City of Denton

Meeting Agenda Planning and Zoning Commission

Wednesday, May 13, 2026

- A. [FP26-0012b](#) Consider a request by Mack Mattke of Kimley Horn & Associates on behalf of CATDENTON 35 for a Final Plat of Summit 35 Addition. The approximately 68.175-acre property is generally located east of North Interstate 35, north of Loop 288, and southwest of Highway 77 (North Elm Street) in the City of Denton, Denton County, Texas. (FP26-0012b, Summit 35, Julie Wyatt)

SURVEYOR:	Kimley»Horn				
	6160 Warren Parkway, Suite 210 Frisco, Texas 75034		Tel. No. (972) 335-3580 Fax No. (972) 335-3779		
Scale	Drawn by	Checked by	Date	Project No.	SHEET
1" = 150'	MBM/JCC	KHA	APRIL 2026	063411024	1 OF 4

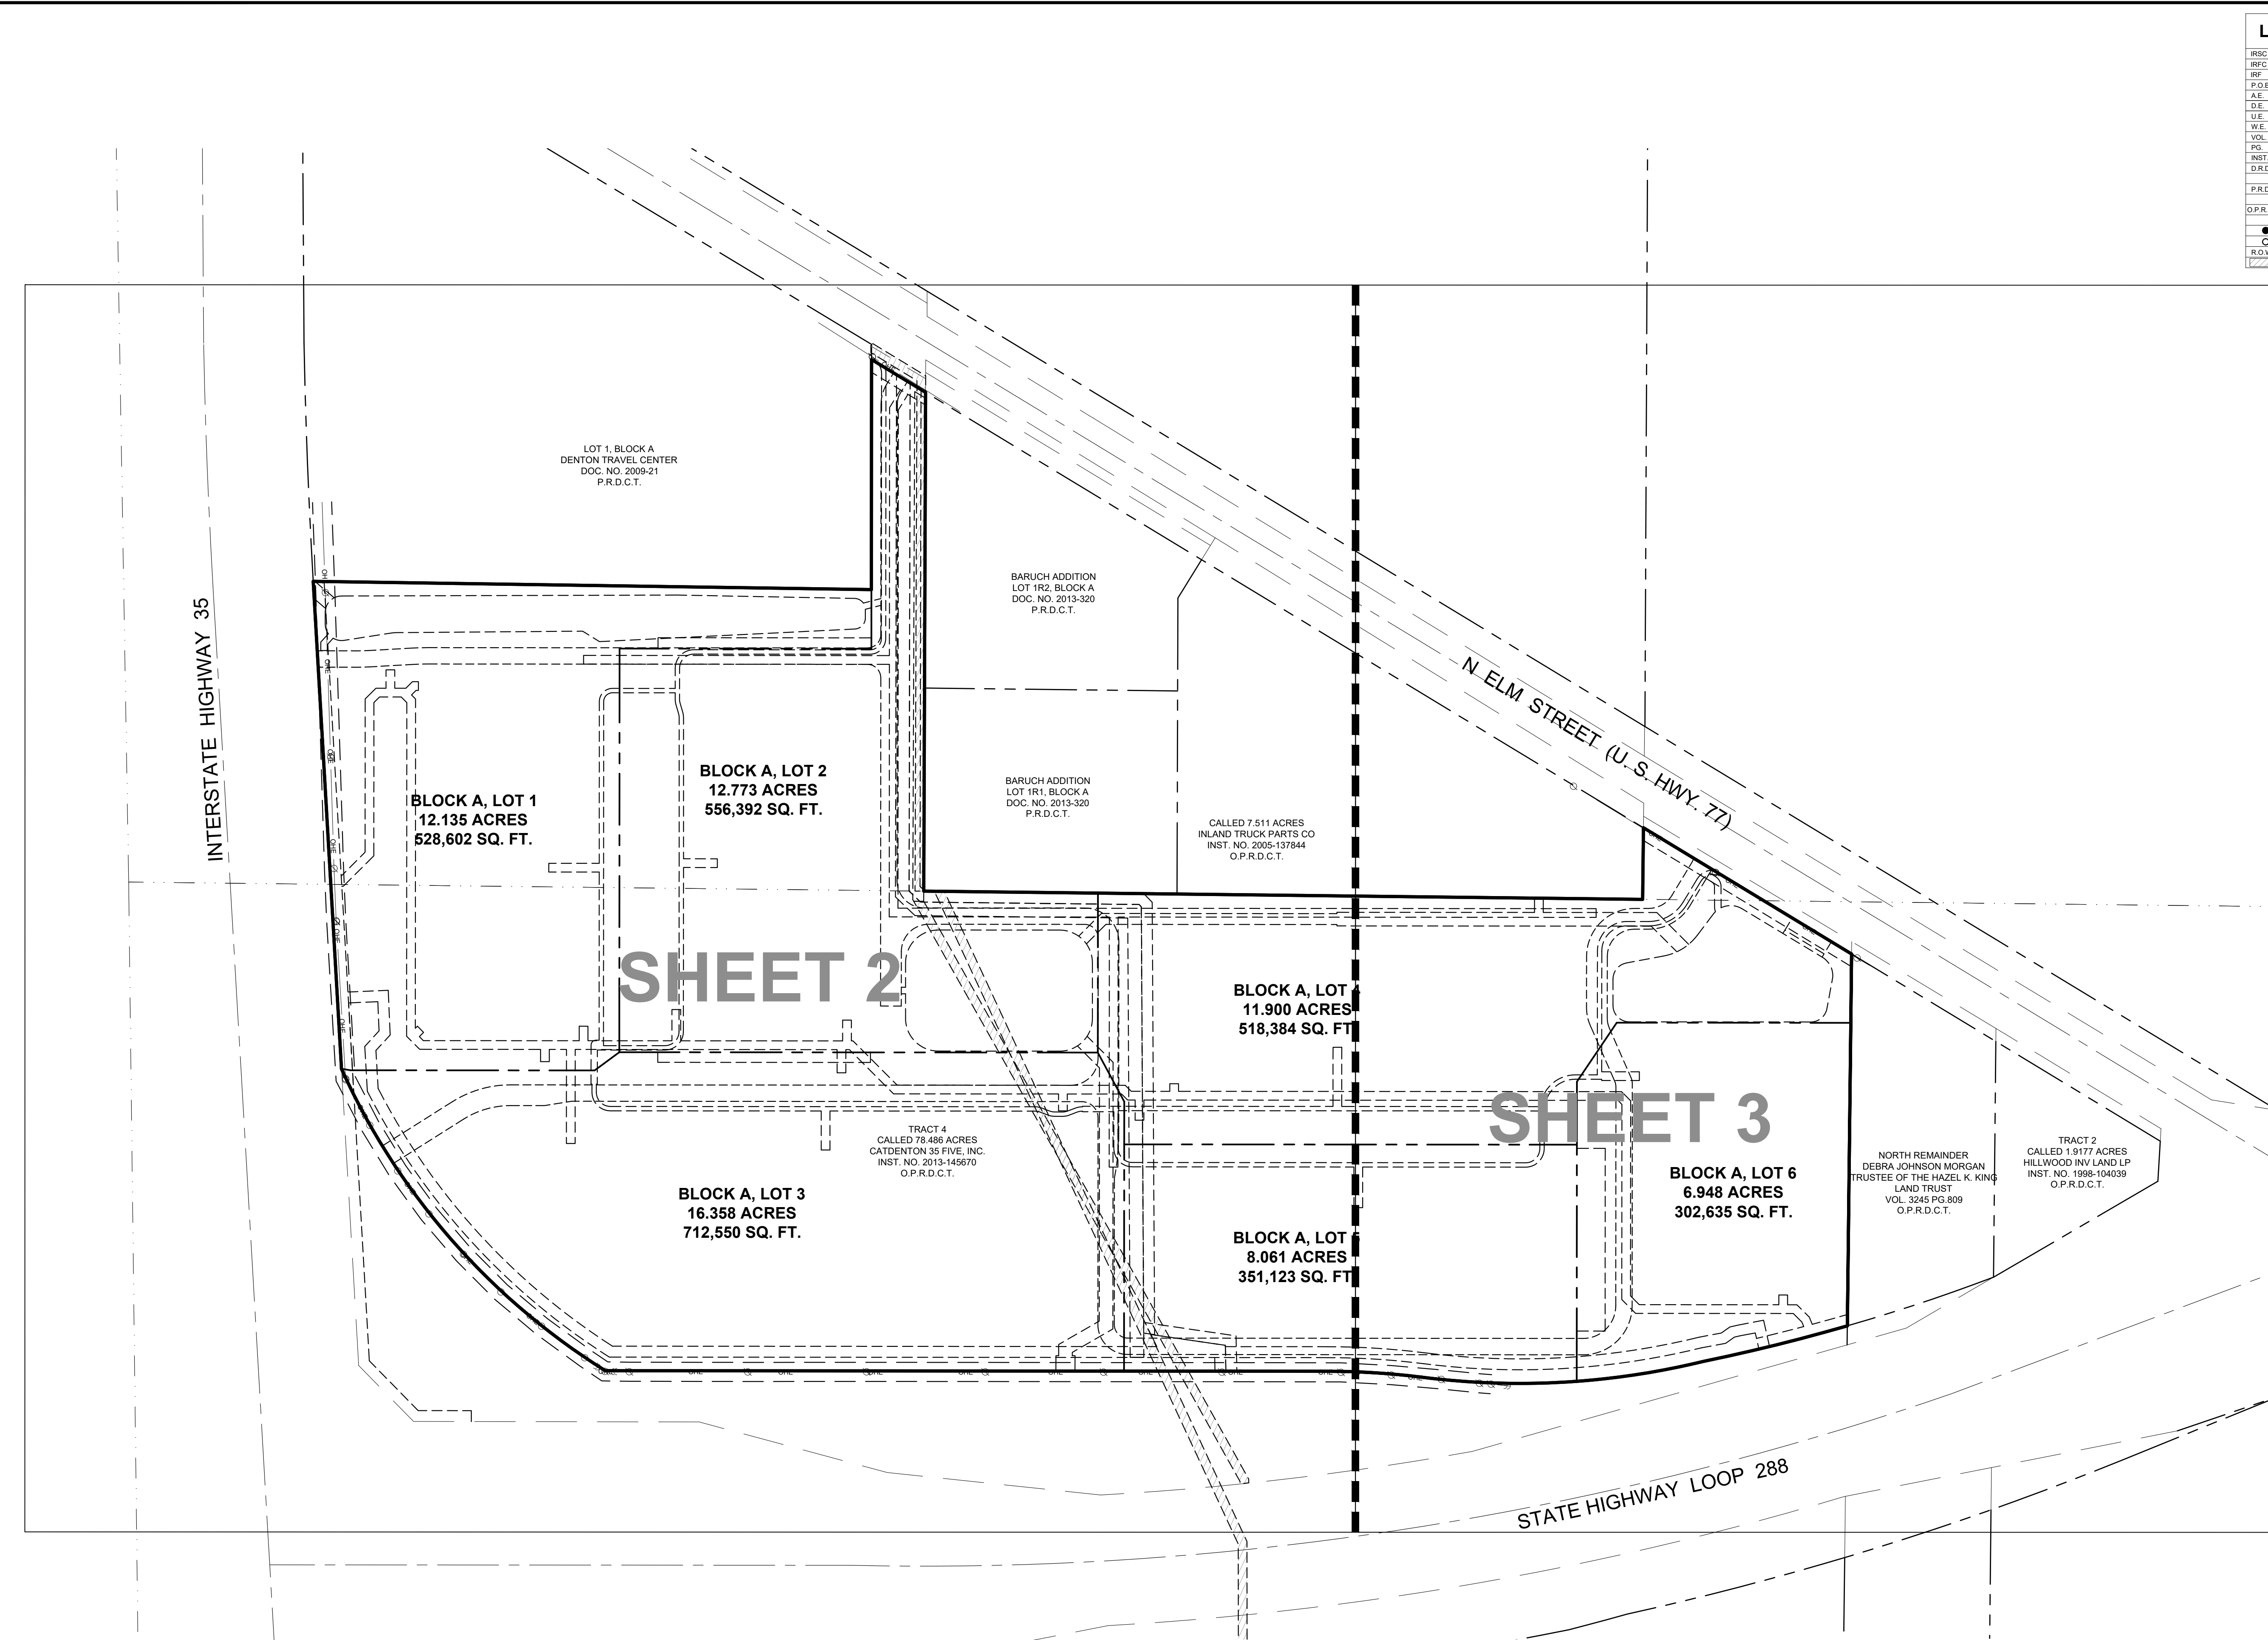
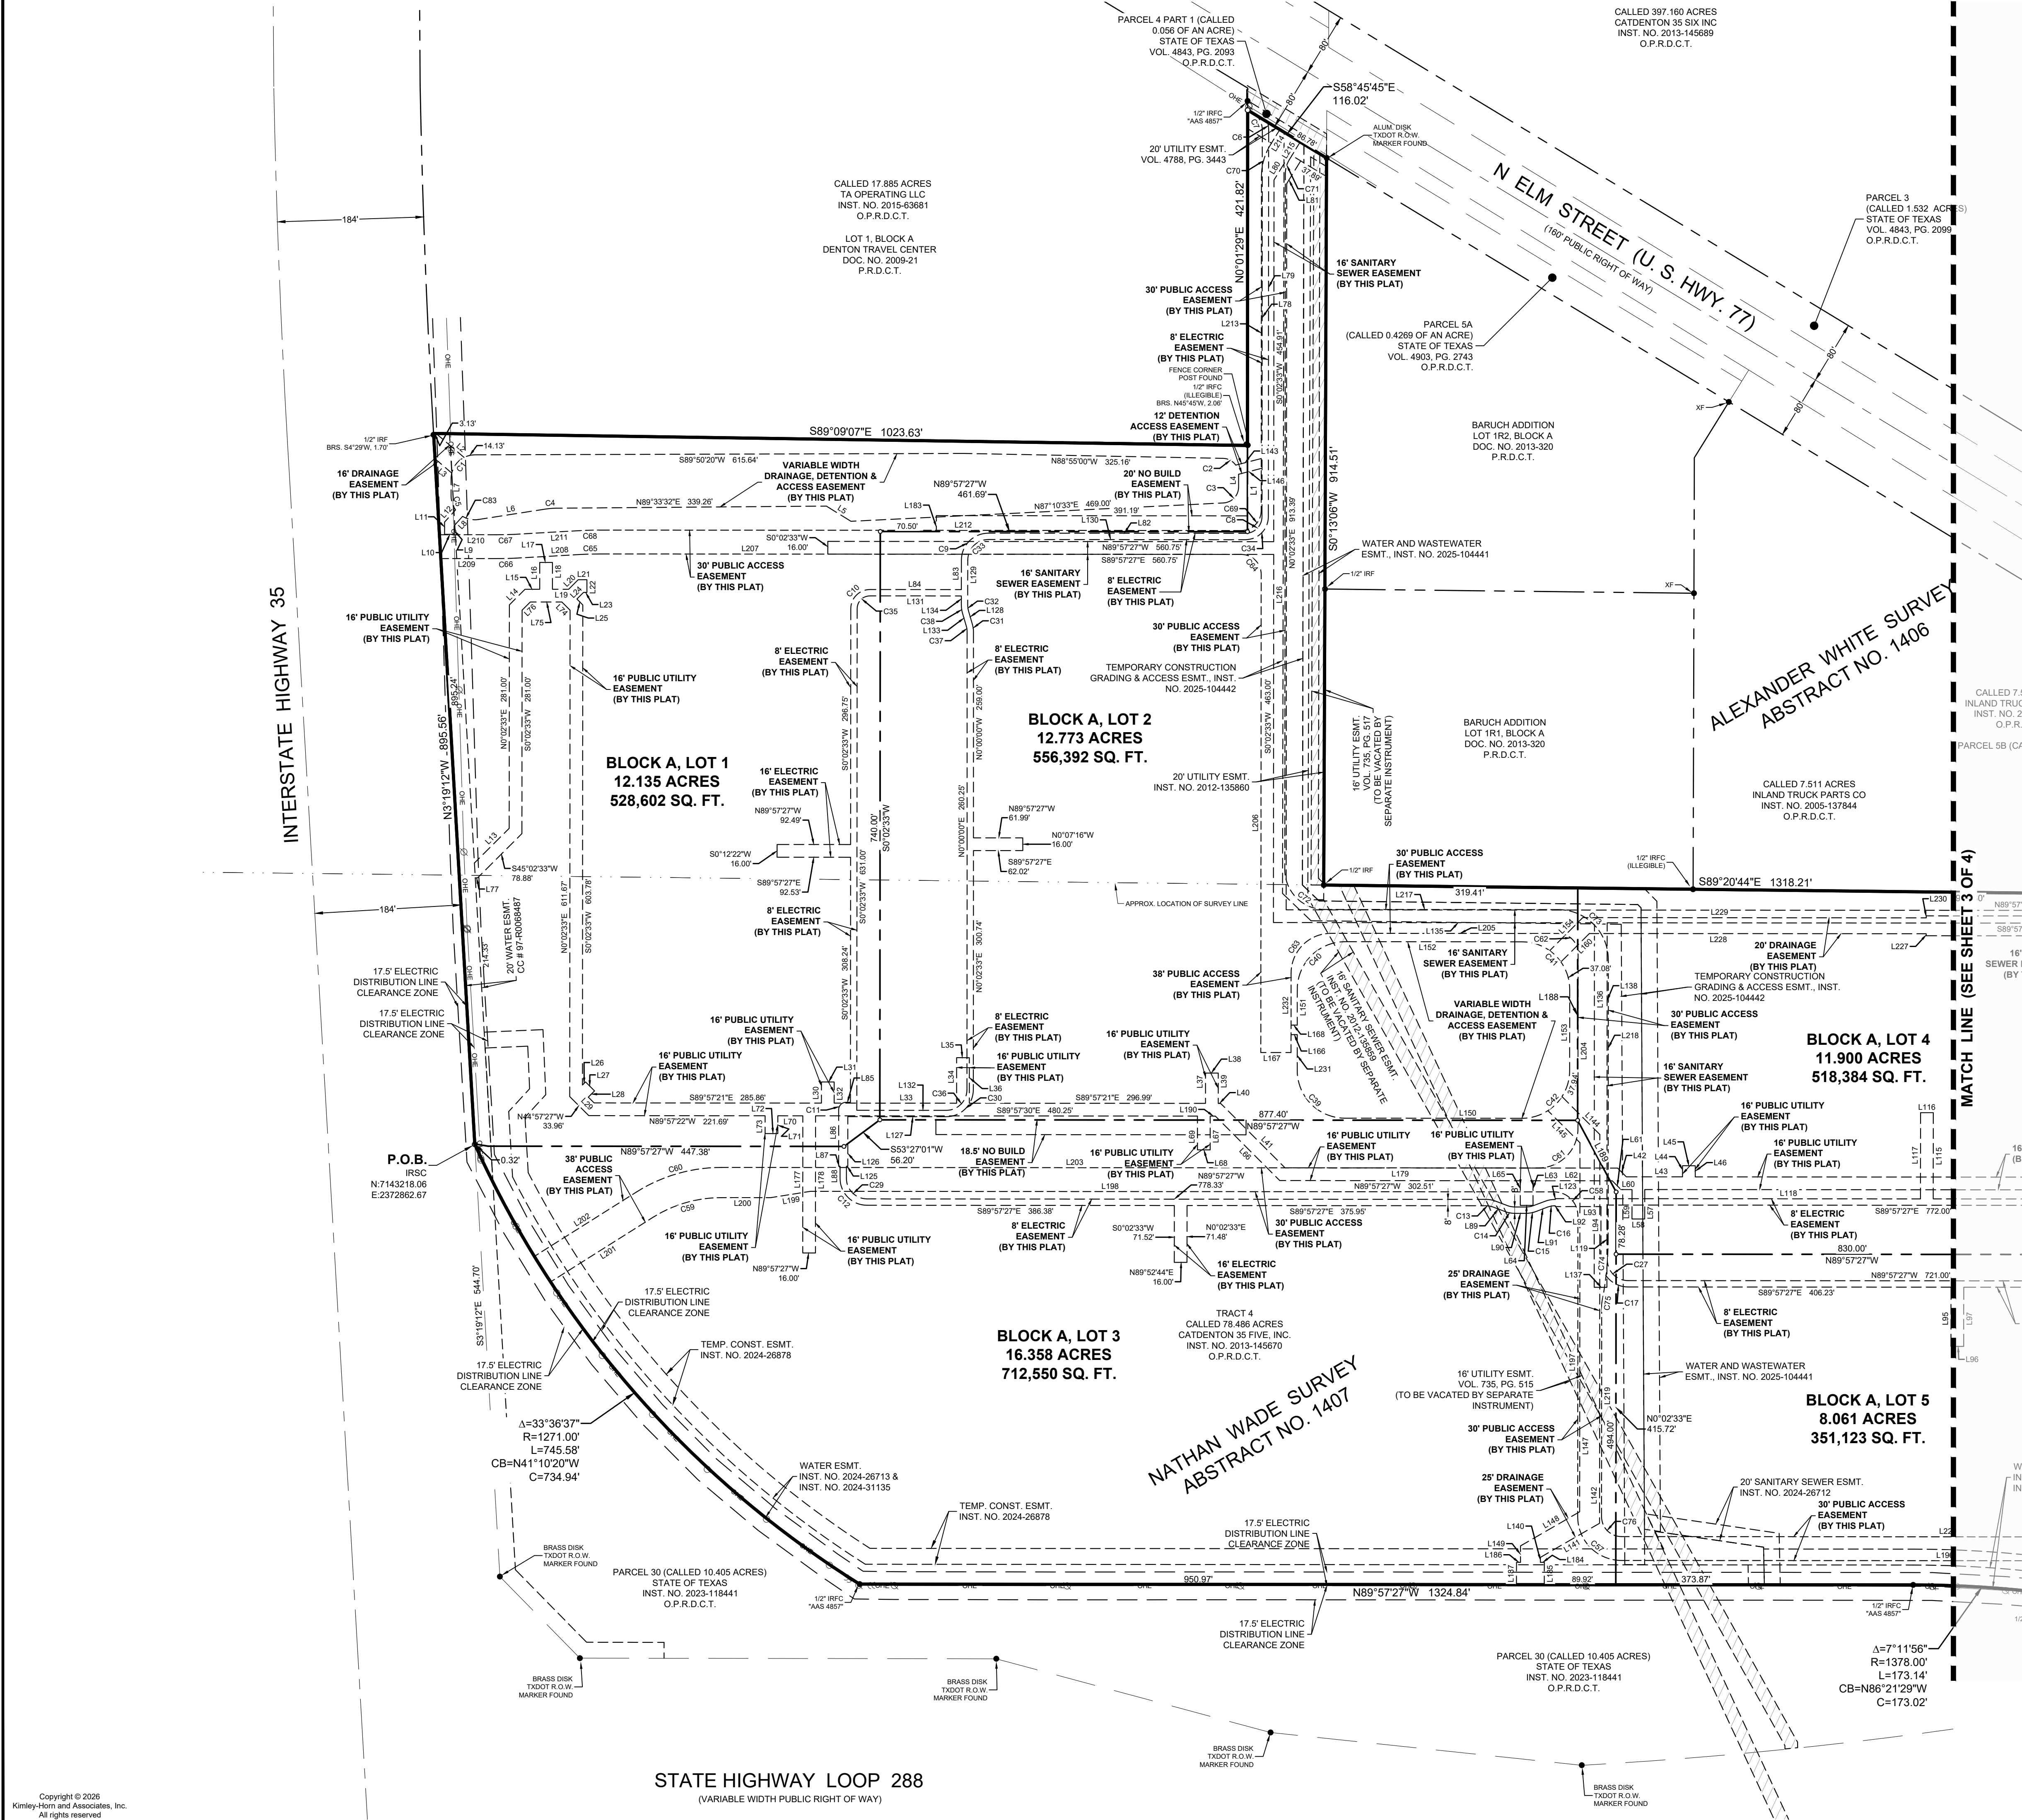
Approval Criteria Applicable to all Applications (DDC Section 2.4.5.E)		Compliance		
		Met	Not Met	N/A
2. Prior Approvals				
a. The proposed development shall be consistent with the terms and conditions of any prior land use approval, plan, development agreement, or plat approval that is in effect and not proposed to be changed. This includes an approved phasing plan for development and installation of public improvements and amenities. Findings: The proposed Final Plat is consistent with the zoning requirements. In order to comply with the criterion, the following must be addressed: Pending CEP25-0080 approval (DDC 2.6.4C.2.d)		☐	☒	☐

4. Compliance with this DDC				
a. The proposed development shall comply with all applicable standards in this DDC, unless the standard is to be lawfully modified. Findings: The Final Plat does not comply with the applicable DDC requirements as described herein. See Criteria #2 and 15 for details.		☐	☒	☐

5. Compliance with Other Applicable Regulations				
a. The proposed development shall comply with all other city regulations and with all applicable regulations, standards, requirements, or plans of the federal or state governments and other relevant jurisdictions. This includes, but is not limited to, wetlands, water quality, erosion control, and wastewater regulations. Findings: The proposed Final Plat does not meet all criteria set forth by the Final Plat Checklist, authorized by DDC Subsection 2.6.4D.3. See Criteria # 2 and 15 for details.		☐	☒	☐

15. Whether the development will substantially comply with all requirements of this DDC. Findings: The Final Plat does not comply with the applicable requirements of the Denton Development Code as described herein and as outlined below: 1. Drainage easements are subject to further review based on pending comments from CEP25-0080. Boundaries sha also be dimensioned (DCM 4.12 and FPC 3.7) 2. Proposal shows drainage and detention easement encroaches into No Build Easement. Provide information as to what types of encroachments are permitted (DDC 7.8.10) 3. Confirm allowable improvements in No Build Easement. If none allowed, fire lane access will encroach into this easement and must be relocated. (DDC 7.8.10)		☐	☒	☐

16. Whether the development will comply with the applicable technical standards and specifications adopted by the City. Findings: The Final Plat does not comply with the applicable technical standards and specifications as described herein. See Criteria #2 and #15 for details.		☐	☒	☐

On behalf of the owner and applicant, I request that the final plat associated with FP26-0012 be granted a 30-day extension at the May 13th Planning and Zoning commission meeting in order that staff's comments may be more fully addressed for consideration at the May 27th, Planning and Zoning commission meeting.
